MeshSat field kit V2, Option A(i) lid pack: sheet A1-1 arrangement B in plan: the lid module, the QMX set and every face part under the lid

MESHsat-1357, stream a1mech, 29 Sep 2026. Case frame: X east, Y toward the hinge (back) wall, Z up from the base floor, lid closed. mm. Prototype design, AI review: nothing built, bought or fitted; analytical success is not physical verification.

MeshSat field kit V2, Option A(i) lid pack: sheet A1-3 the arrangements that fit, and the owner decision

MeshSat field kit V2, Option A(i) lid pack: sheet A1-6 the base pockets: section 8's 4S6P at the same worst figures

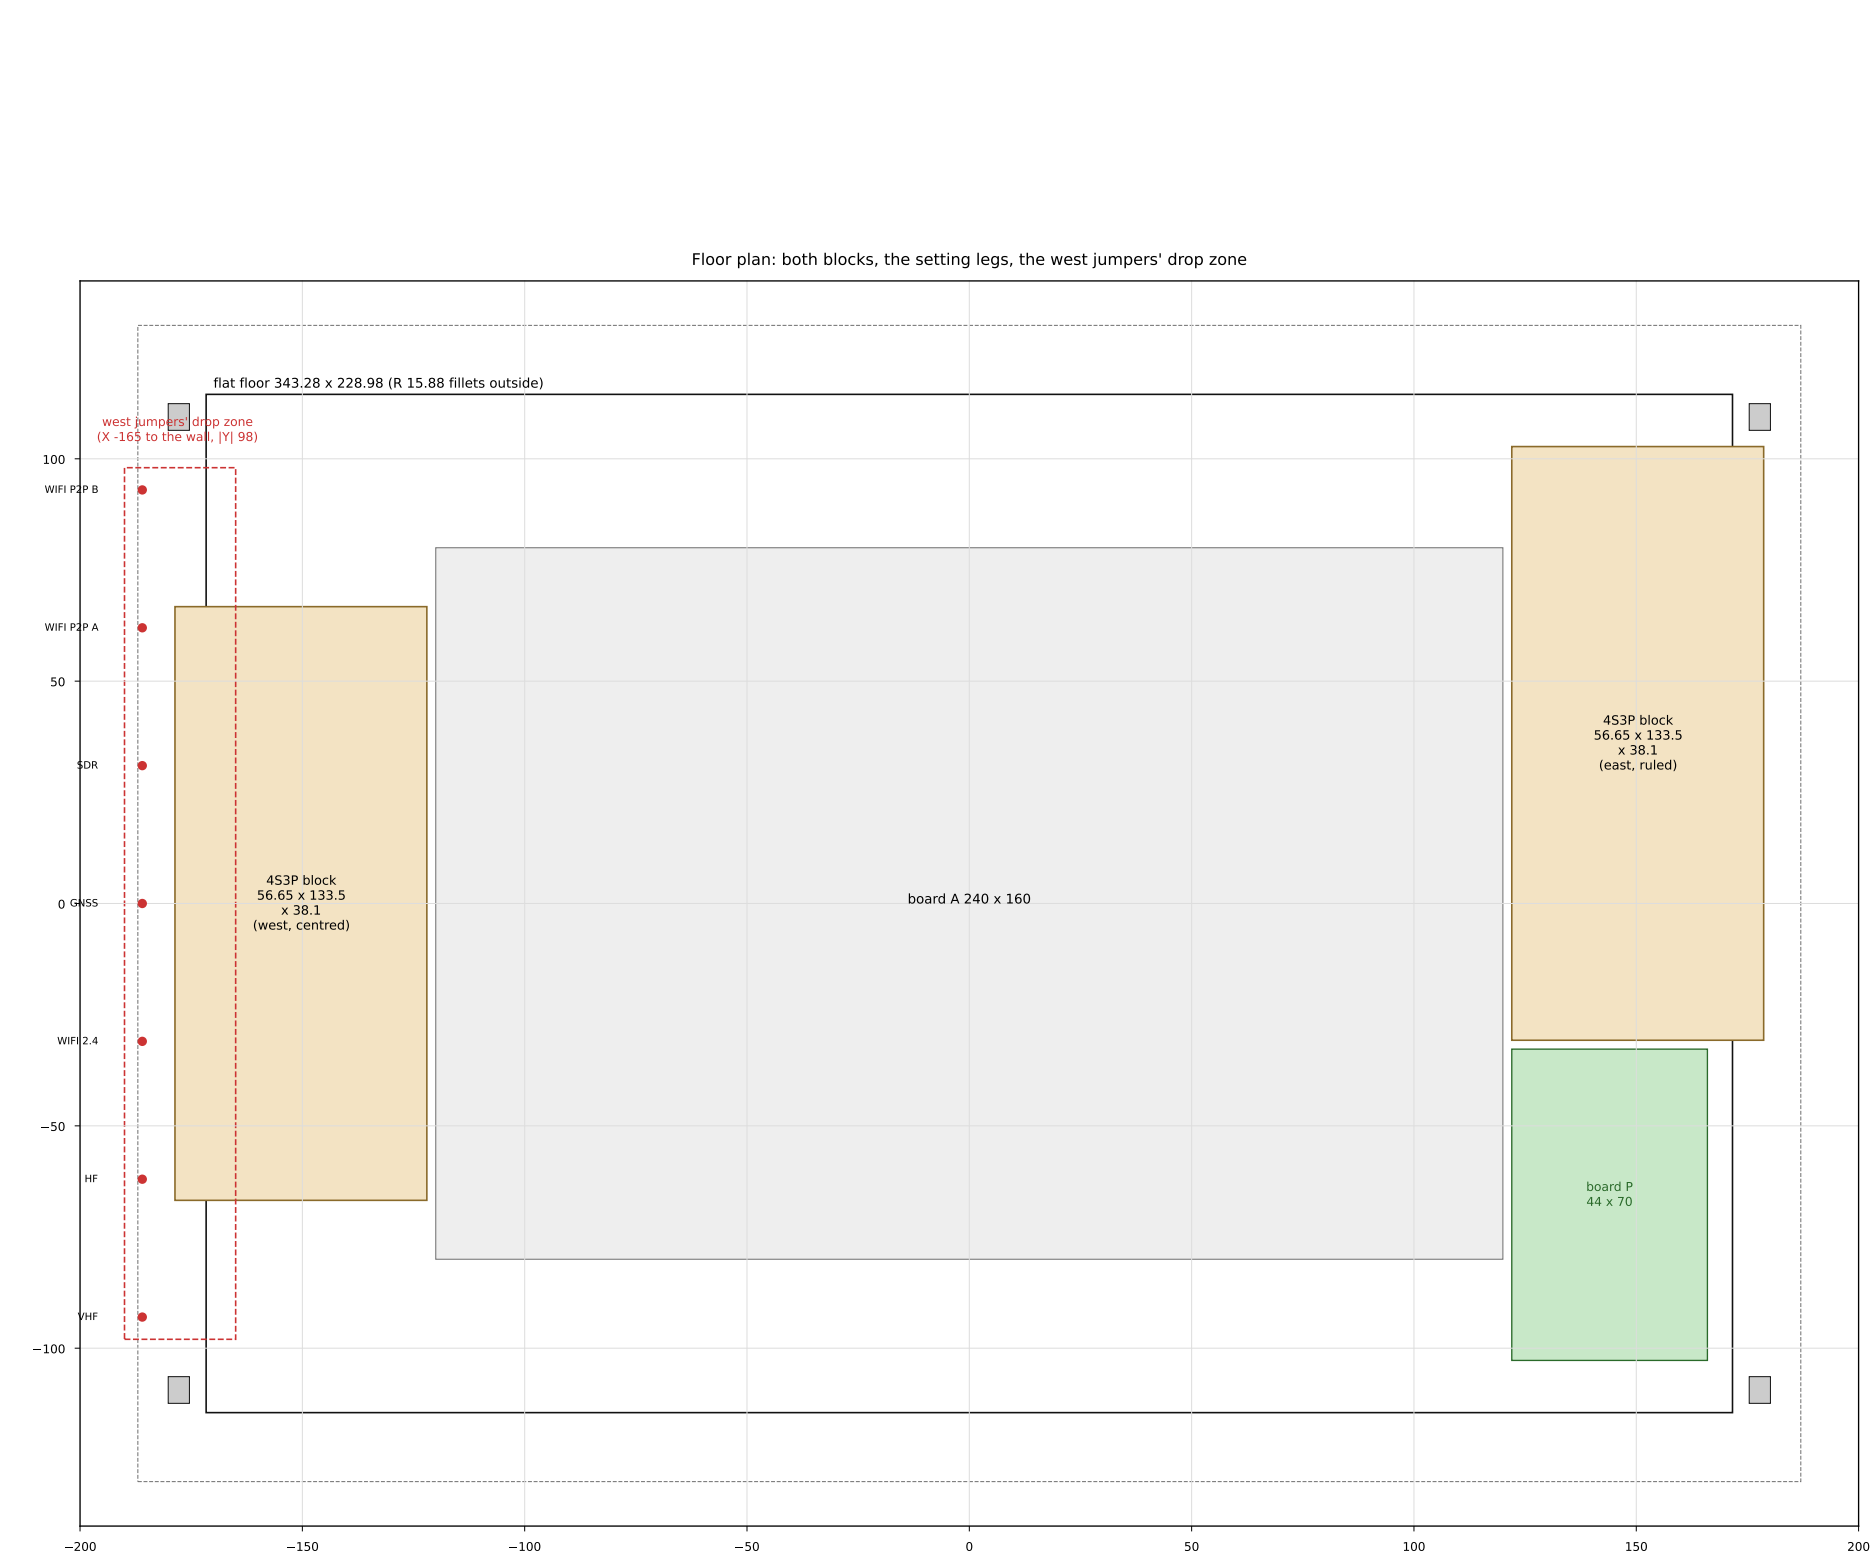
ROW	worst	x2	verdict
M4a	1.85	0.85	OPEN: placed by hand; T4
M4aw	1.85	0.85	OPEN: placed by hand; T4 (mirror: Peli's cavity and
M4b	7.38	6.38	MET
M4bw	7.38	6.38	MET (mirror: Peli's cavity and the RF entry plates a
M4c	3.18	1.80	MET
M4cw	3.18	1.80	MET (mirror: Peli's cavity and the RF entry plates a
M5	1.77	0.27	OPEN: placed by hand, the legs' locator; T4
M5w	37.77	36.89	MET (the block's Y place is not ruled; centred here)
M6	3.66	2.90	MET
M6w	3.99	n/a	OPEN: the x2 reading is not computed by A06's tool;

WEST RF JUMPERS: 5 of 7 west cables (Y -62, -31, 0, 31, 62) fall onto the west block; the slot over it is 7.19 at the worst less C33's zone (3.99); the only drop east of it is its 2.0 gap to board A, under one RG-316 (2.49): FAILS AS ASSUMED, held OPEN (section 8b, the M17 class): the west RF entry is re-planned before the west block is taken. Hold-down S-27 open for both blocks.

The mirror rows hold only because Peli's cavity is the same at both ends (ribs at Y 0 and +-76.2 on both end walls, R 15.88 on all four floor edges: VERIFIED) and the RF entry plates share one outline (panel1450 C4).
